## INDIANA DEPARTMENT OF TRANSPORTATION

### STANDARDS COMMITTEE MEETING MINUTES

RE: Minutes for the June 22, 2006 Standards Committee Meeting

707-SDPC-01, AASHTO Type II, III, or IV I-Beams  
707-SDPC-02, Indiana 54" Bulb-Tees  
707-SDPC-03, Indiana Bulb Tees Greater Than 54" in Depth

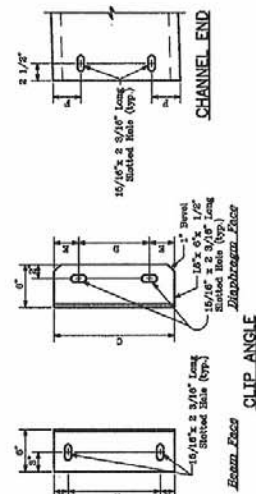
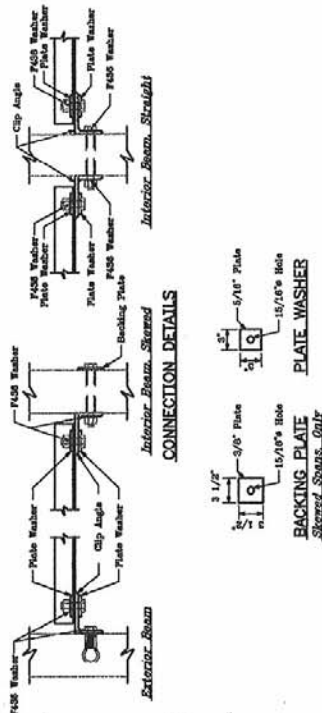
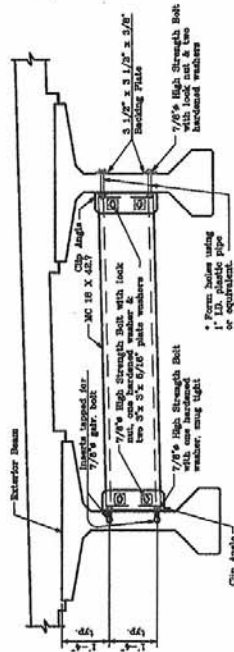
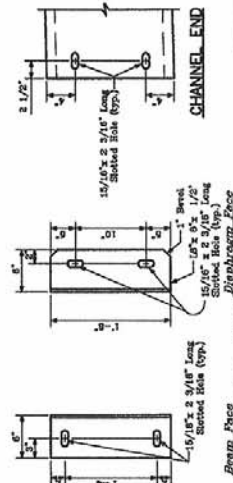
Item No. 12-4  
Mr. Wright  
Date: 6/22/06

Action: Passed as revised  
Effective - January 2007 Letting  
2008 Standards Edition
